RFI 86

Project: COOLEY LABORATORY RENOVATION
Job: 3146 COOLEY LAB, PPA# 10-0023
Customer: STOFMT MSU BOZEMAN

Item: CMU Lintel at Coiling Door Type: ARCH/STRUC
Reference: S1.2, S2.0 Spec. Section:
Attachments: Drawing

*Extend CMU Down
Move Slab Ceiling
Down*

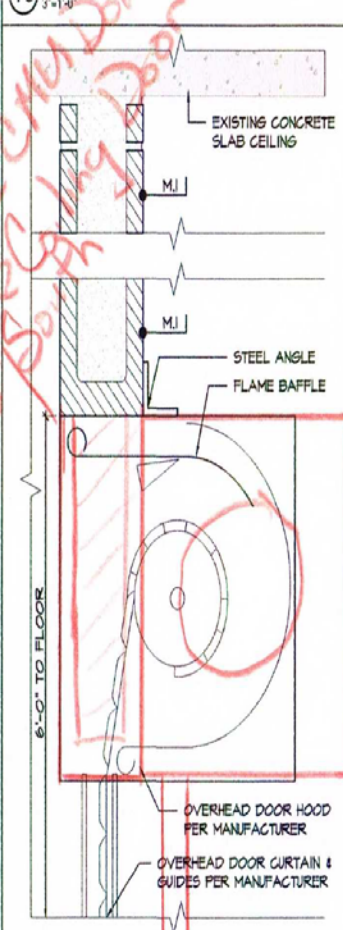
The opening for the coiling door requires a CMU lintel that is 6"x24". The ceiling height in the basement is 9'-6" +/- . The coiling door requires an opening 8'-3 1/2" for a 7' door opening. This does not allow for the proper CMU lintel.

It is possible to move the coiling door to the south to flush up with the inside edge of corridor CMU wall and bring the the CMU wall down an additional 13" see the attached sketch. Please let us know.

Response: Relocating the coiling door to the inside face of the CMU as sketched in your proposal is acceptable. Confirm with the door supplier that the rating will not be affected by the new mounting location/type.
